Evita 2 dura

Technical Service Bulletin # 11

Re: Product improvement for all units before S/N ARNB-0110
(Service Pack 1)

Update: May 24, 2000

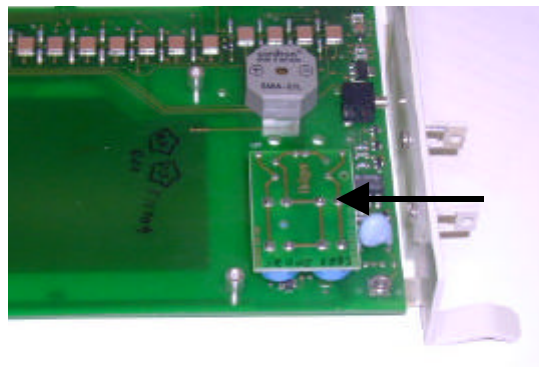
- The kit is delivered with 2 modified Expiration Valve caps to prevent tendency of resonance vibration. Note: Not all valves are affected.
- A second loudspeaker is installed in most units starting with a S/N ARMX-YYYY (1998 production). Some users/operators complained that the audible alarms are too loud. If applicable, the second loudspeaker is to be disconnected. The cable harness with the connector must be fasten with a cable tie in such way that an electrical contact to housing or other parts is not possible.
